DART AEROSPACE LTD	Work Order:	105210
Description: Crosstube Assembly (206L High Fwd)	Part Number:	D206-667-143
Inspection Dwg: D206-667-143 Rev: C		Page 1 of 2

DRAWING NO. D206-667-143	TITLE CROSSTUBE ASS'Y (206L HIGH FWD)	REV. C	DART AEROSPACE LTD ENGINEERING ORDER		D.E.O. NO. D206-667-143-C-1	SHEET NO. SHEET 1 OF 1	SCALE NTS
DRAWN <i>qp</i>	CHECKED <i>ASS</i>	MFG. APPR. <i>[Signature]</i>	APPROVED <i>[Signature]</i>	DE APPR. <i>[Signature]</i>			
DATE 11.07.15	DATE 11.07.20	DATE 11.07.21	DATE 11/07/21	DATE 11.07.21

REPLACE MAGNOBOND WITH PROSEAL

D206-667-143		REV. C		DART AEROSPACE LTD ENGINEERING ORDER		D.E.O. NO. D206-667-143-C-2		SHEET NO. SHEET 1 OF 1		SCALE NTS	
DRAWN AJS		CHECKED		MFG. APPR. <i>E</i>		APPROVED <i>AD</i>		DE APPR. <i>AD</i>			
DATE 12.08.02		DATE 12.08.02		DATE 12.08.02		DATE 12.08.02		DATE 12.08.02

TURNING DETAIL

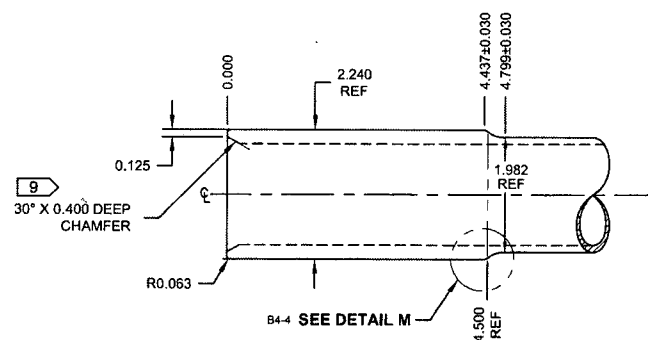
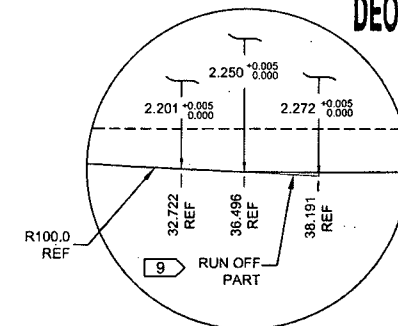
1-Fill tube with sand & install plugs DT8534 on both ends as per Folio FA087

2-Turn first side as per Folio FA087

3-Blend transition lines only, **do not sand whole tube**

1-Turn second side as per Folio FA087

2-File down transition lines smooth.

3-Blend transition lines only, **do not sand whole tube**:
*Use mill bastard file, brush file repeatedly with file card.FOLIO REV: ABDWG REV: C
